Geneva, 9-13 November 2015 Item 6 (a) of the provisional agenda **Proposals for amendments to Annexes A and B of ADR:** construction and approval of vehicles

Proposal for amendment by the informal working group on the electrical system of vehicles carrying dangerous goods

Transmitted by the Government of the Netherlands¹

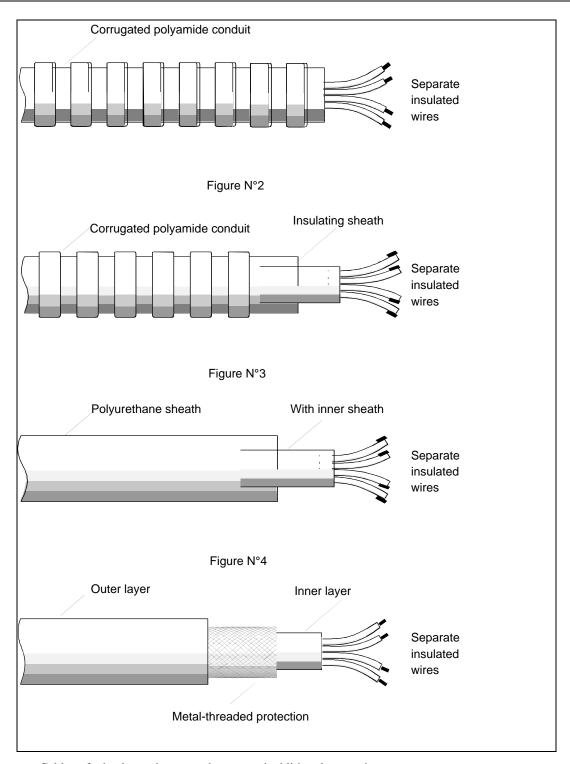
9.2.2.2.2 Additional protection

Cables located to the rear of the driver's cab and on trailers shall be additionally protected to minimize any unintended ignition or short-circuit in the event of an impact or deformation.

The additional protection shall be suitable for the conditions during normal use of the vehicle.

The additional protection is complied with if multicore cables in conformity with ISO 14572:2011 are used or one of the examples in figures 1 to 4 below or another configuration that offers equally effective protection.
